Project: WBS 42825.1.1 (B-5227)
Bridge #24 on SR 2428 over Hunting Creek
Wilkes County

Subject: MINUTES OF MEETING

PURPOSE/DESCRIPTION:		Pre-Bid Meeting
DATE & TIME:		Tuesday, April 13, 2010 1:00 pm
LOCATION:		NCDOT Bridge Management Unit Small Conference Room Raleigh, North Carolina
ATTENDEES		
Name	Representing	Telephone Number
	See Meeting Roster	
Jim Mondolfi	Ko/Florence & Hutcheson, Inc.	919-851-6066

PROJECT REFERENCE NO. B-5227
SHEET NO. 14
ROADWAY DESIGN ENGINEER
ENGINEERING SEAL
DAVID C. MALLER
3-2-10

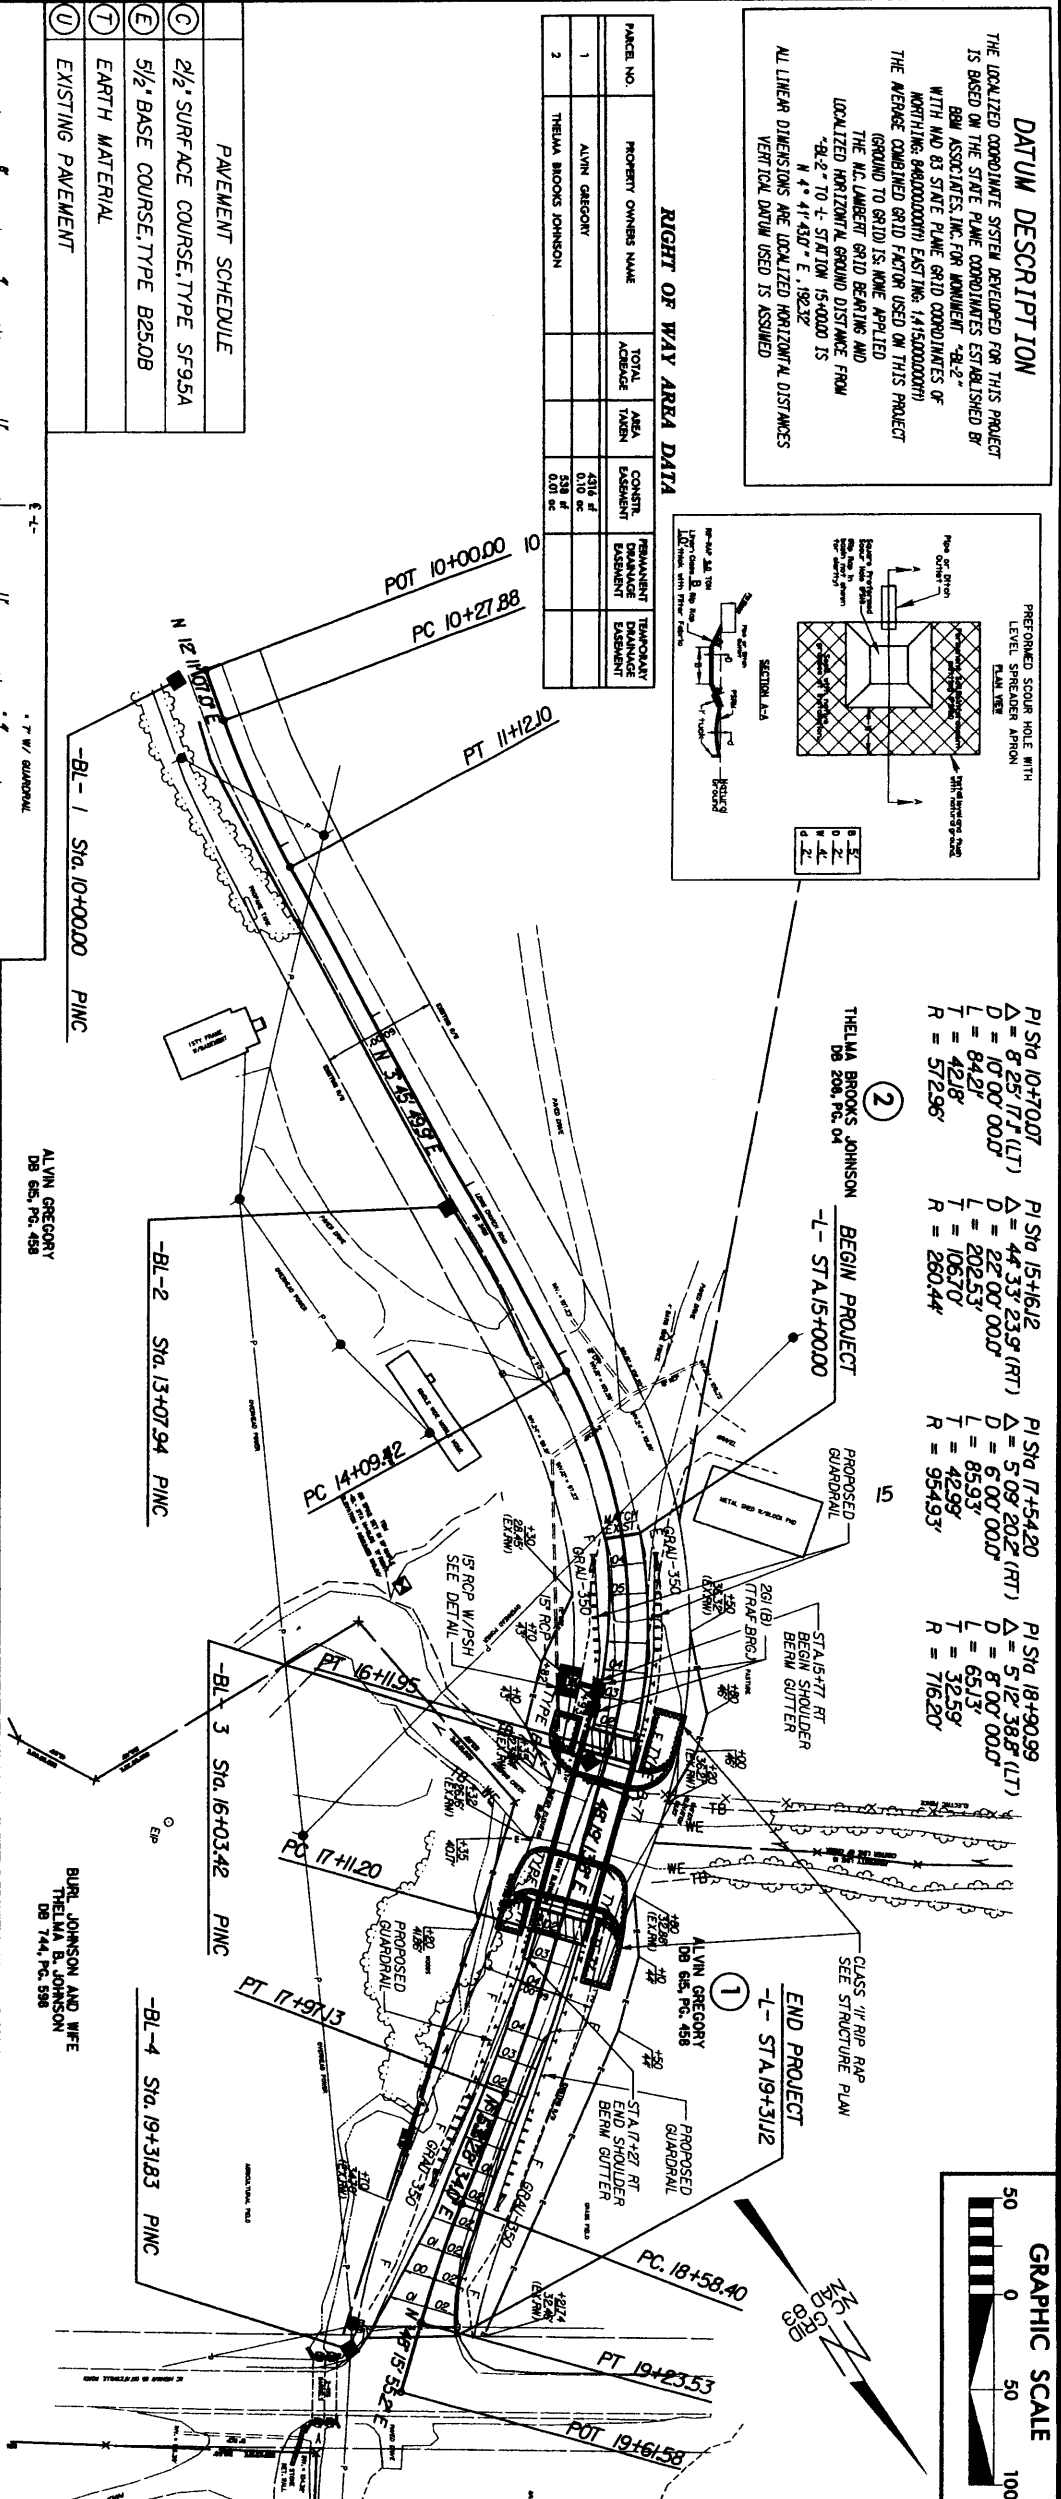
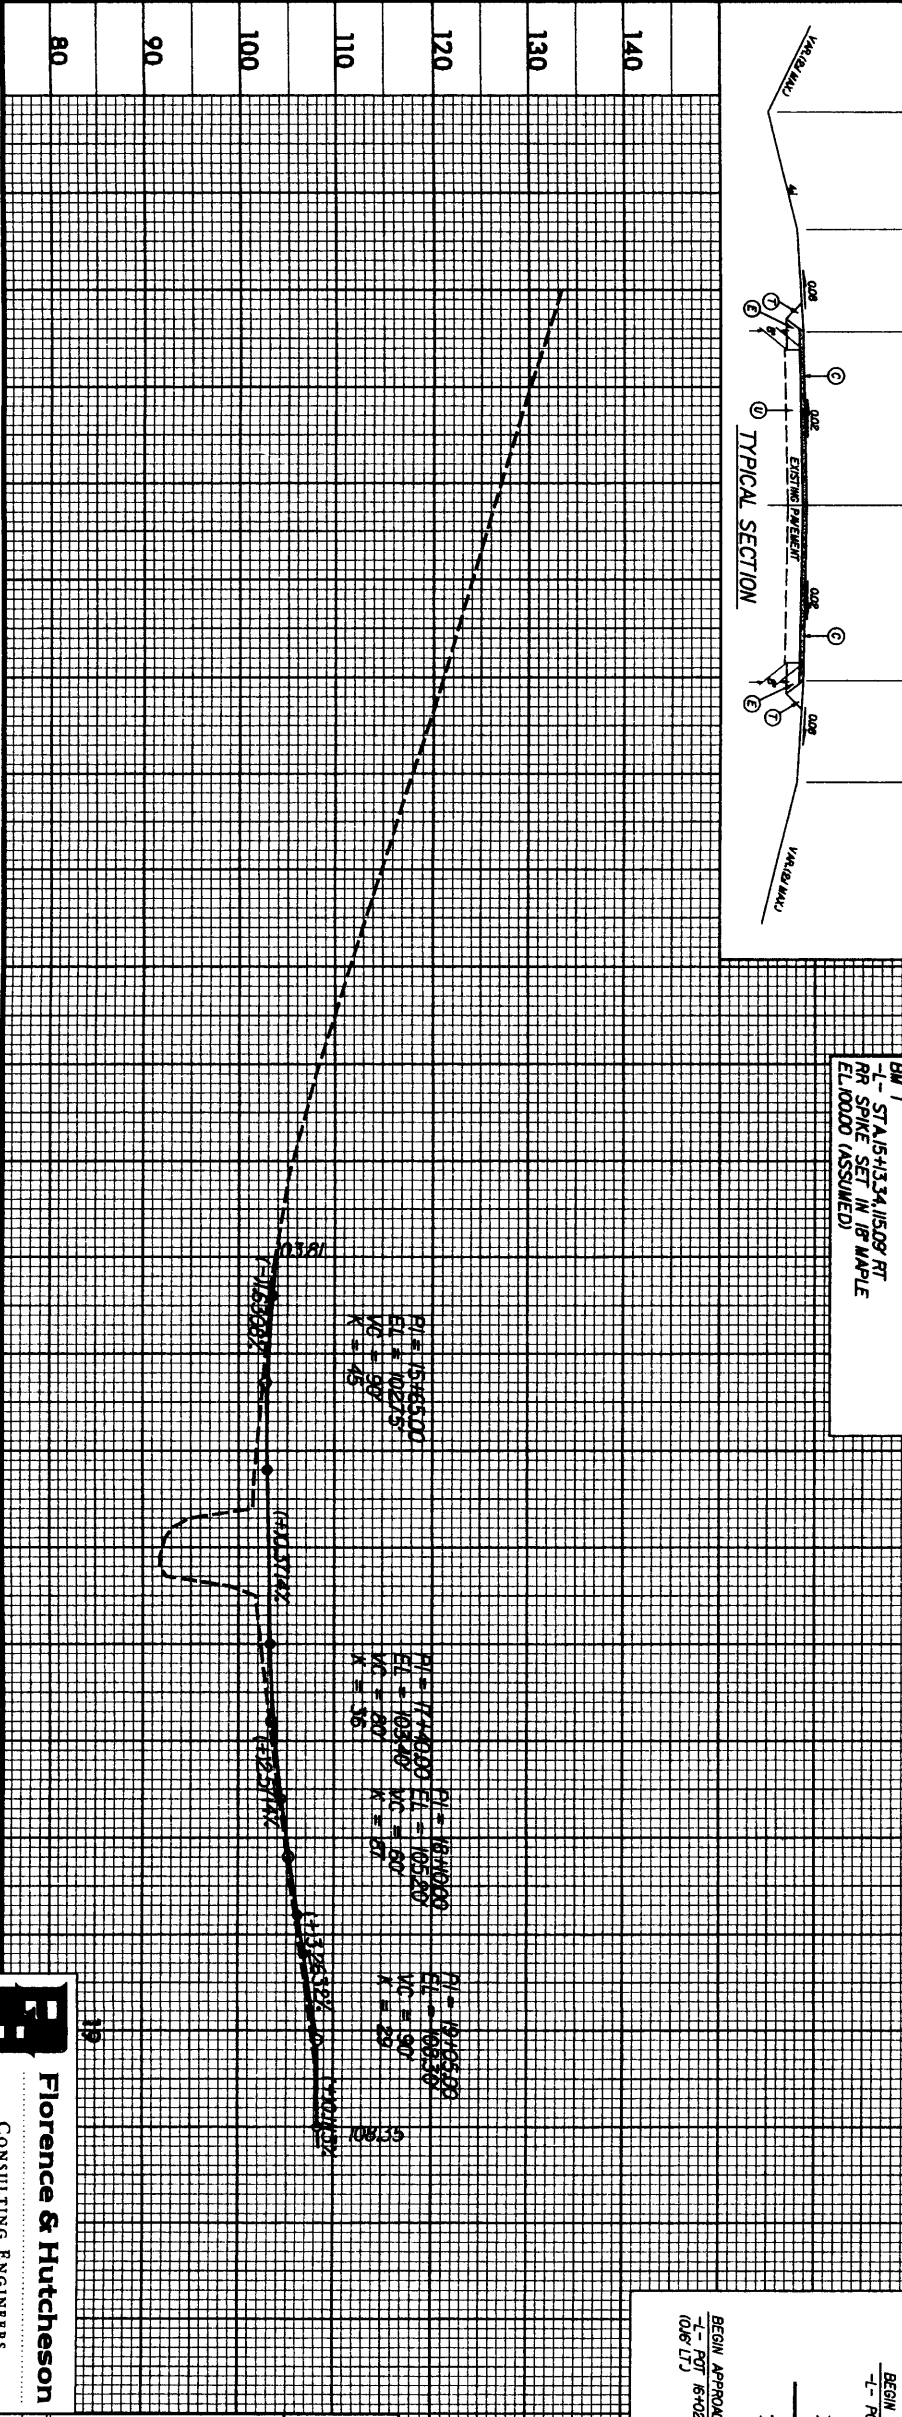
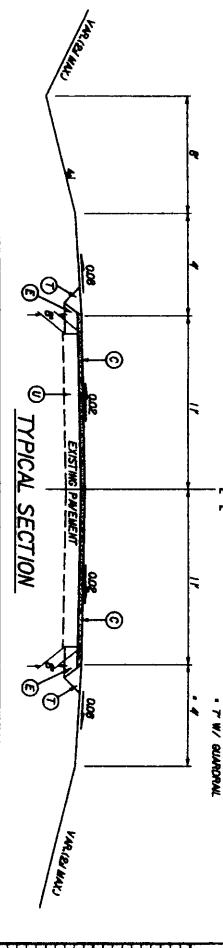
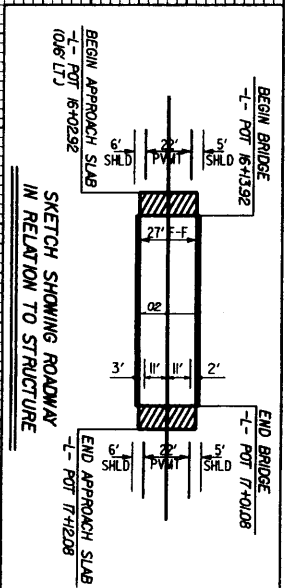
- 5) Bid Sheet, line 25. The quantity shown for "Matting for Erosion Control" is verified as being correct.
- 6) On Drawing 5 of 23 of the Plans, the dimension 6'-8 ¼", locating the guardrail anchor assembly connection is revised to 7'-5 ¾".
- 7) Roadway Plan, Drawing 14 is revised. The revised plan sheet is attached.
- 8) Page 77 of the Proposal under Construction of Superstructure, paragraph one should read, Furnish and install prestressed concrete cored slabs, etc. Cored slab units **will not** be supplied by the Division.
